# Cliffe Lane, GOMERSAL

Design Response  
January 2024

The purpose of this document is to review the planners design comments and their concerns raised for the proposed site plan layout at Cliffe Lane, Gomersal. This document will address and justify the design rational behind the proposed layout.

Refer to drw 1694-101\_rev-I\_Site Plan Layout

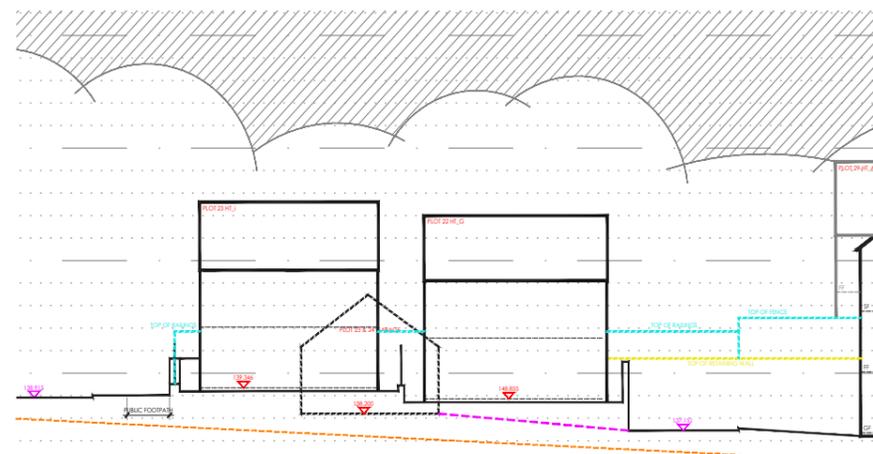
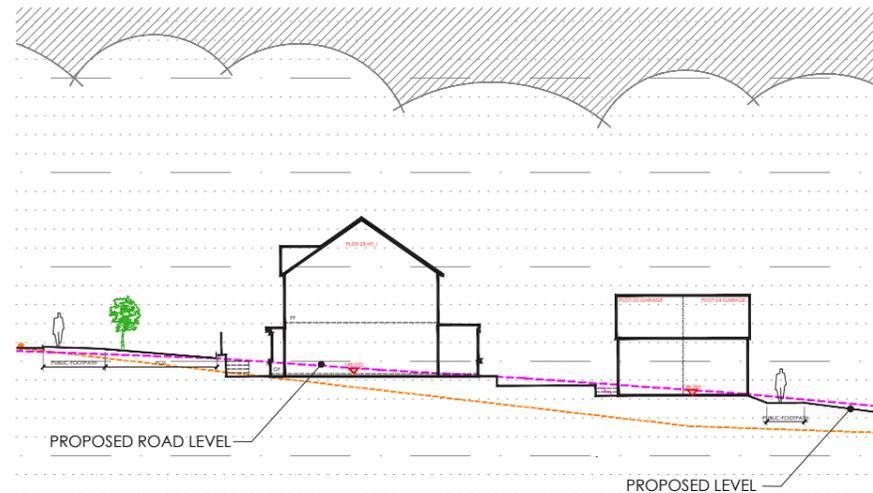
On initial inspection and review, plots 23 and 24 need to be flipped around to face onto the open space and plots 01, 10, 29, 35, 64, 69, 70, 78, 79, & 87 need to also have bespoke design onto open space as per paragraph 7.14 of the Housebuilders Design Guide SPD on account of their prominent positions relative to highly visible areas. This will not only benefit the visual appearance of the development, but will also have the dual purpose of increasing surveillance of open spaces from multiple perspectives so that risk of crime is minimised. Simply adding a window onto the side elevations of buildings is poor design response and the SPD provides examples of height/elevational treatment mixes that are appropriate.

As shown below plots 23 and 24 have been rotated and are now faced to overlook the pos area, this will provide more natural surveillance to the public open space. The above updates to plots 23 and 24 means the shared double garage is now located at the rear of the dwellings. The proposed finish floor level of the double garage will tie in with both the estate road and private drive; with small garden walls and stepped patios addressing any level change within the curtilage the units.

Refer to drw 1694-101\_rev-I\_Site Plan Layout

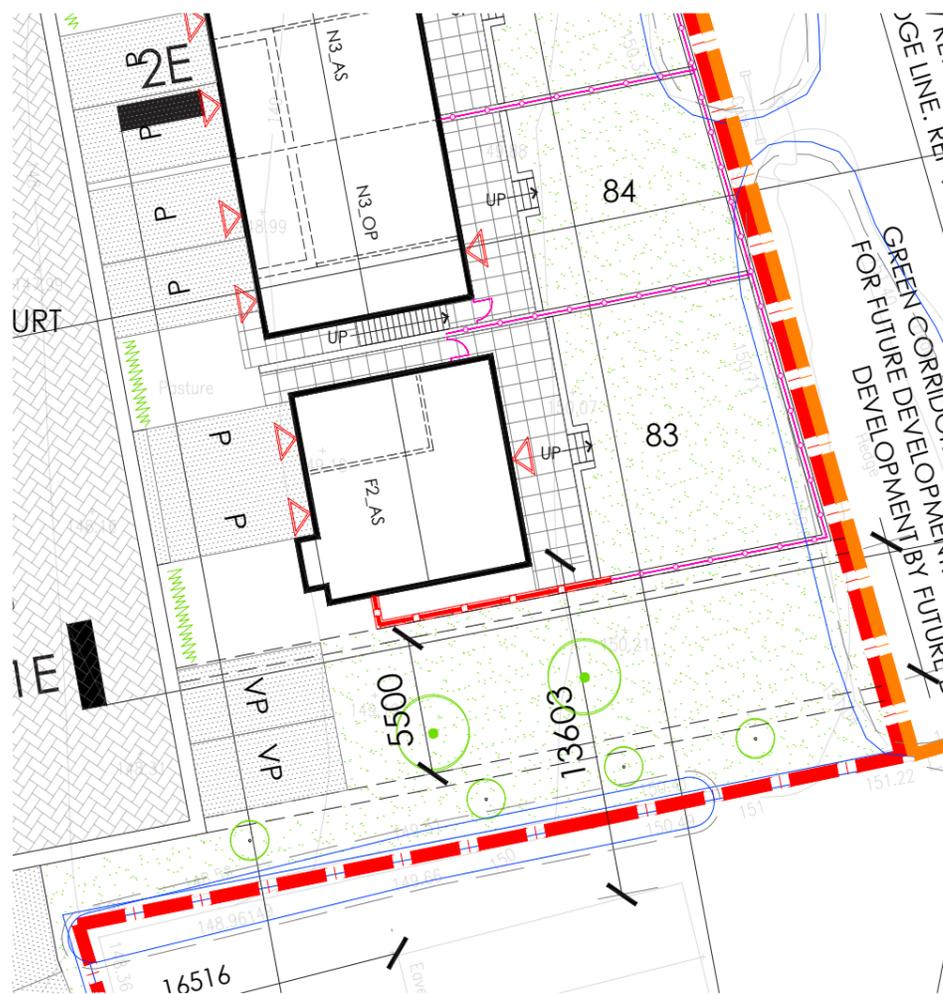
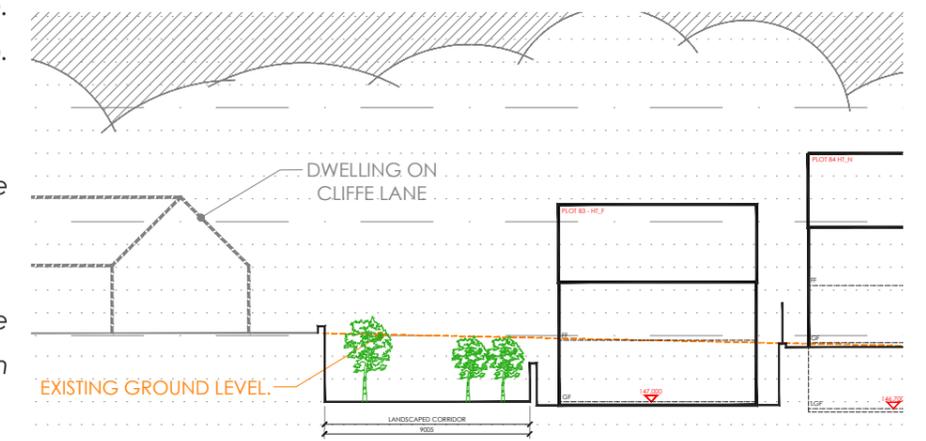
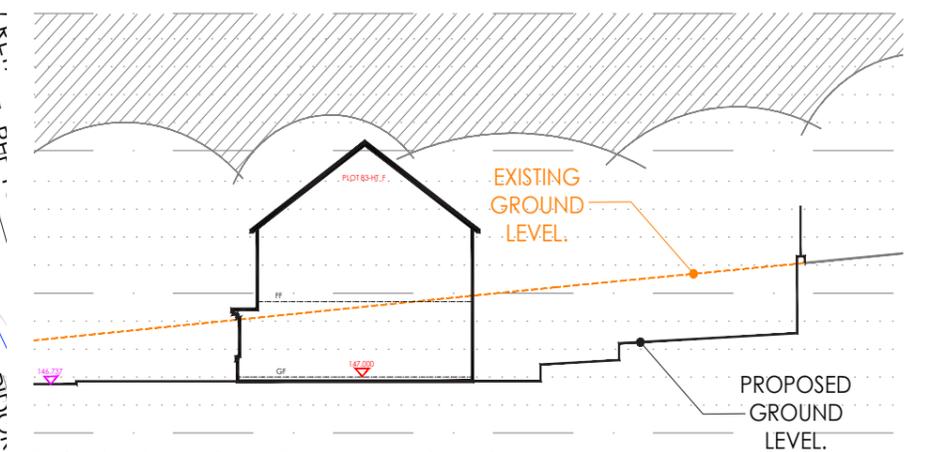
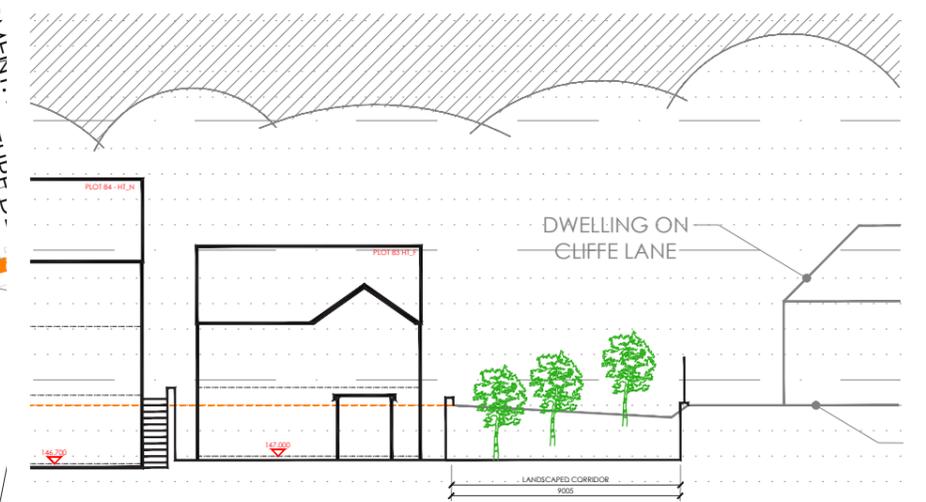
It is also possible that the area south of plot 83 to allow access into the residual parcel of the housing allocation is also too narrow, however @Mark Berry will be evaluating this in his response. The proximity of a carriageway to plot 83's side boundary would appear to create a significant residential amenity issue, similarly, there appears to be limited space for a footway, should gradients indicate that a shared surface is not possible through to the residual parcel. The placement of visitor parking spaces at the junction point would also likely incur issues with resultant loss should the residual parcel come forward in the fullness of time, this is again, unacceptable.

The site plan layout has made allowances for additional road infrastructure alongside plot 83 to access the additional land to the east. The allowance can accommodate all road types, such as; 5.5m estate road with a 2m footpath down one side, 5.5m mews court with 600mm margins or a 5.5m private drive. The latter being the preferred option as the addition land with only house 5no. units.

Please note the client has no legal obligation to provide road infrastructure from the proposed site layout to the land to the east.

The cost attached to the works to implement the connecting road would be at a high cost, due to the civil and structural engineering involved to deal with the ground levels.

Refer to drw 1694-101\_rev-I\_Site Plan Layout

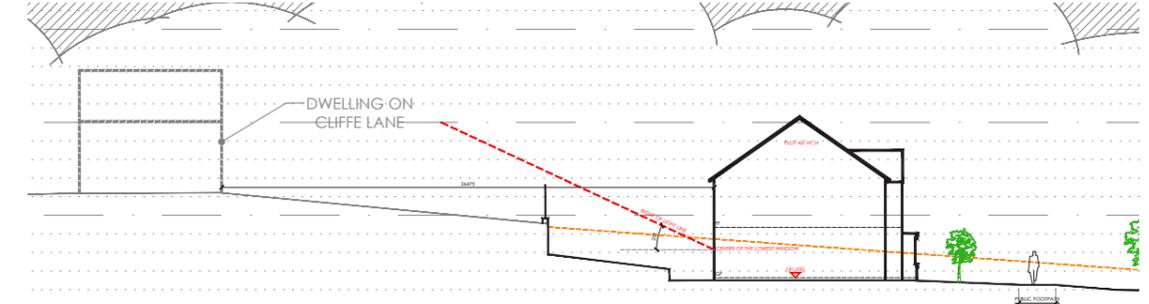
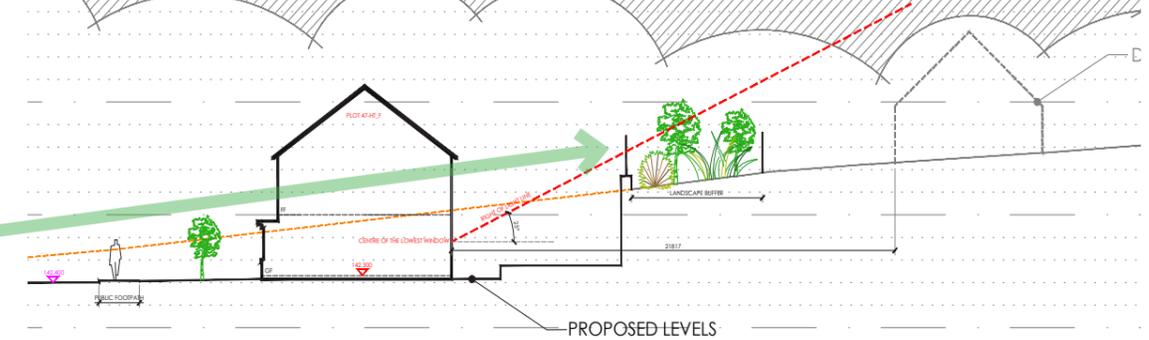
One final thing, there does appear to be an issue with 21m distances provided between the main rear elevations of plots 46 and 47 which does not account for rear extensions to some existing properties on Cliffe Lane. It might be that plot switches (i.e. plots 48 and 49 for 47 and 48) as well as parking layout revisions to bring the building line forward could go some way to addressing this as you're currently 3m short.

The current site plan layout complies with the separation distances, of 21m provided between main to main and 12m main to side elevations. Please note some of the existing dwellings on Cliffe Lane that consist of single-storey bungalows have newer built additions (conservatory's) to the rear elevation. As quoted from the separation distances and amenity SPD document. Conservatory's are not classed a primary elevation and falls under a new addition to the building.

A separation distance of 21 metres will be expected at first floor level etc... a single storey extension of 3 metres to each opposing property is feasible which would retain 15 metres between ground floors as extended, i.e.

With the plotting of plots 43 to 53, we are achieving a separation distance of 21m and greater from proposed main elevations to main existing elevations to dwellings located on Cliffe Lane. **A generous landscape buffer is provided within the design behind plots 43 to 53 to allow planted landscaped screening on the southern boundary. The landscape buffer is access via the stairs provided at the end of the private drive.**
